To All Lamborghini Dealers and Licensed Service Point
From Customer Service Department
Subject Service campaign - Fixing ring for canister breather pipe
Group 140.2.03
Attachments -
Date 29.09.2005
Pages 5

Service Campaign - Fixing ring for the canister breather pipe

All Gallardo models until VIN 2620

Picture 1

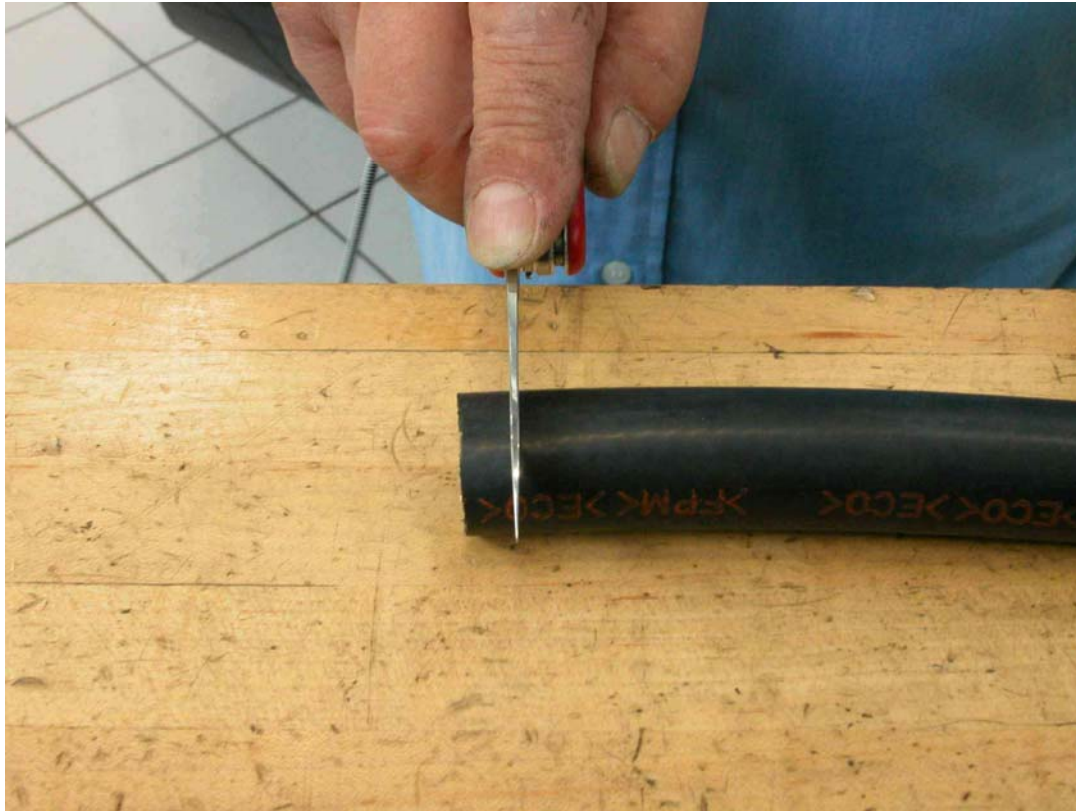
- 1.1 Adopt all precautions to prevent car damages and to work safe.
- 1.2 Raise the car on the lift.
- 1.3 The canister breather pipe must be positioned as shown in the picture below.
Adjust the pipe position in order to have about 20 mm jut (pull the pipe carefully to avoid disconnection).

Add a fixing ring to the canister breather pipe.
